Change Notice

GW Series

Revision to Vertical PC Terminals on GW Rockers & Paddles & GW Illuminated Paddles

Example of GW22LCV before change to the terminals.

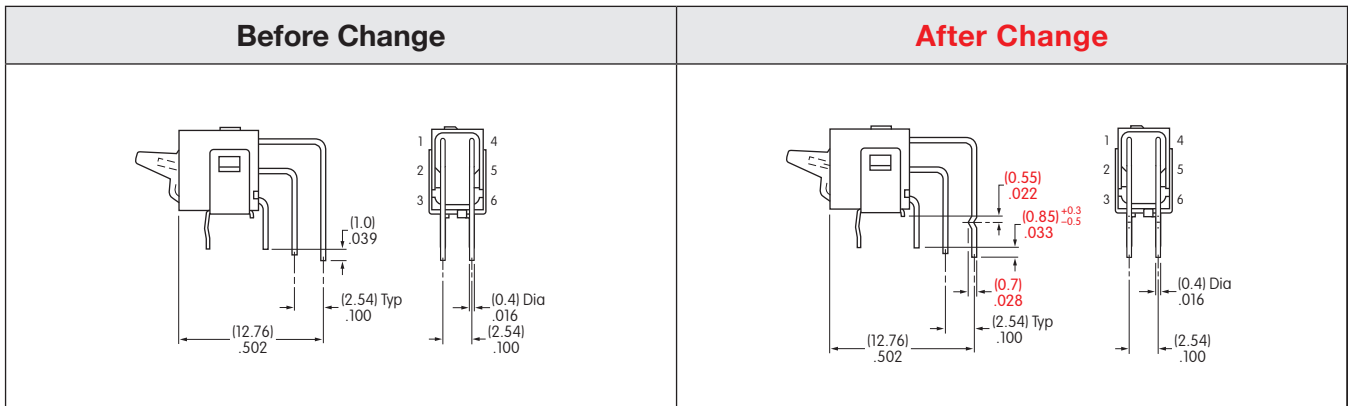
Terminals 1 and 4 will have modifications on GW Rockers and Paddles and GW Illuminated Paddles with vertical termination. These changes will effect both standard and custom products. The table below lists the standard part numbers that will be effected, and the illustrations depict the differences before and after revisions.

The footprint will not be effected by the terminal changes. Contact the factory if further details are needed.
